NCPC File No. 6597

VIETNAM VETERANS MEMORIAL CENTER SITE SELECTION AND DESIGN GUIDELINES

STAFF RECOMMENDATION

VIETNAM VETERANS MEMORIAL CENTER SITE SELECTION AND DESIGN GUIDELINES

View of 'Site A' from Lincoln Memorial

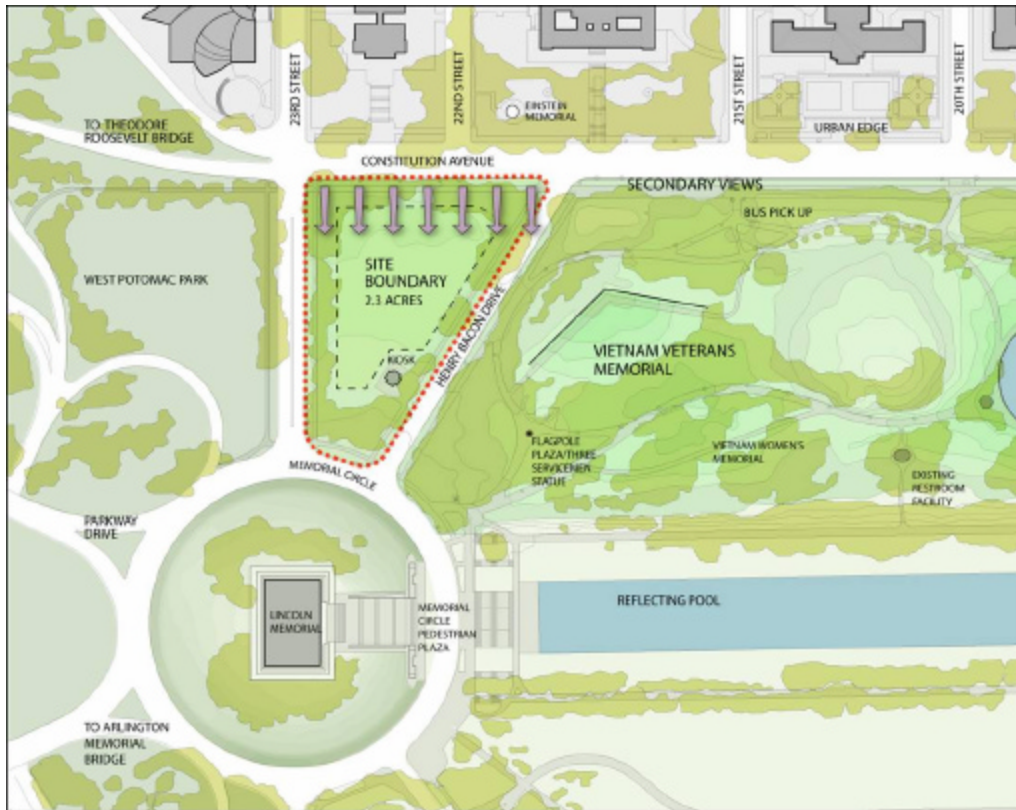
NPS has already heard comments from Commission staff, SHPO staff, and others about the singular importance of the Lincoln Memorial in this setting, and views of it from Bacon Drive, Constitution Avenue, from 23rd Street, NW and from Site A. While the recreational uses of the grounds around the Lincoln Memorial have changed to some degree during the 20th century, the character of the low, grassy setting with trees at the north edge of the site has remained, especially in contradistinction to the hierarchically dominant and ascendant rise of the Lincoln Memorial.

1b states that Site A would not intrude on critical views on the Mall from the Lincoln Memorial steps. Site A is clearly visible from the Lincoln Memorial steps and from the upper platform of the Memorial itself. Elements of the building identified in the proposal, including skylights, ventilation shafts and paved gathering areas for large groups of people

Proposed View Cone through Site with Buildable Area Below

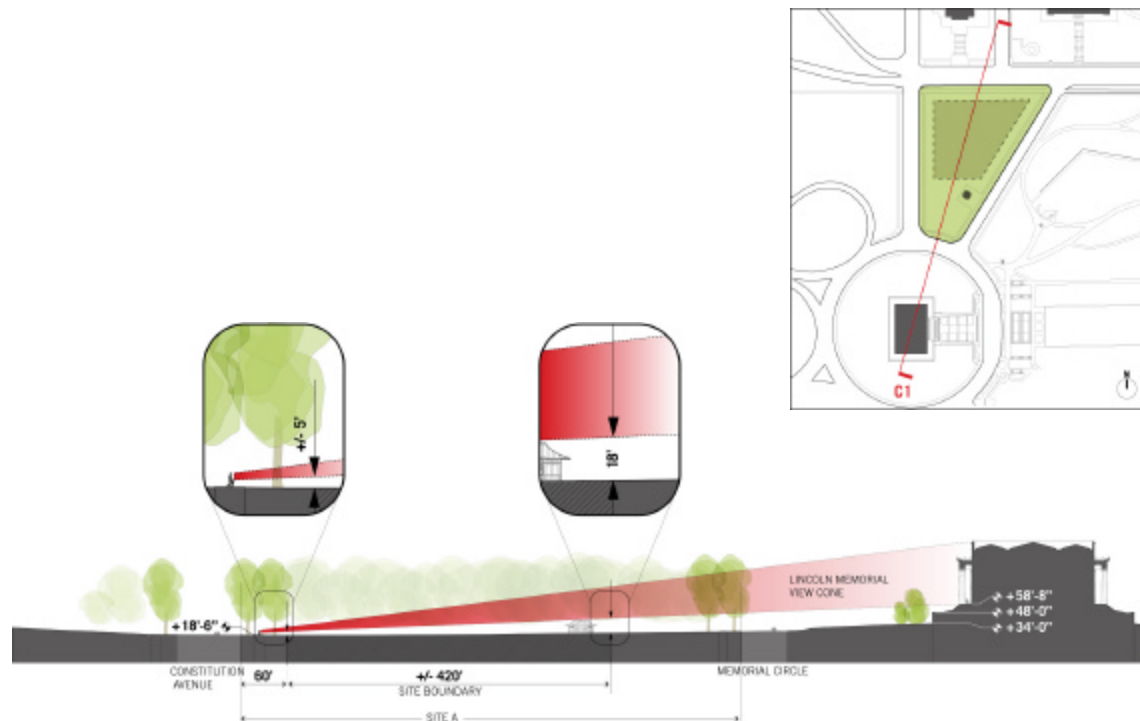
Although not required at the site approval stage, the lack of a defined building program makes it difficult for staff to analyze the potential adverse impacts to this sensitive building site ('Site A'). The design guidelines proffered by the applicant do not satisfy staff's concerns and those expressed by members of the National Capital Memorials Advisory Commission and the State Historic Preservation Officer. The guidelines would allow an above ground portion of the building to be constructed up to 18 feet in height at the south end of the site. Although the applicant states that any elevated portion of the site would be covered in landscape materials, the guidelines would allow an 18 foot high vertical window wall to be constructed along the site's most sensitive side, facing the Lincoln Memorial. Such a window wall would be clearly visible from the steps of the Memorial and from the top of the Memorial itself. Additionally, warping the site to such an extent would make active or passive recreation on site virtually impossible after the building is constructed.

The guidelines state that no above ground portions of the building would be constructed within the grassy panel of the site, but do not preclude that necessary above ground portions would be constructed within the wooded edge of the site surrounding the grassy panel.

Paved areas of the building, including entry and exit walks and gathering spaces at both the entrance and the exit would have a major visual impact on the site, even if held to ten percent (10%) of the site area, and would also impact the physical use of the space at ground level for other active or passive uses.
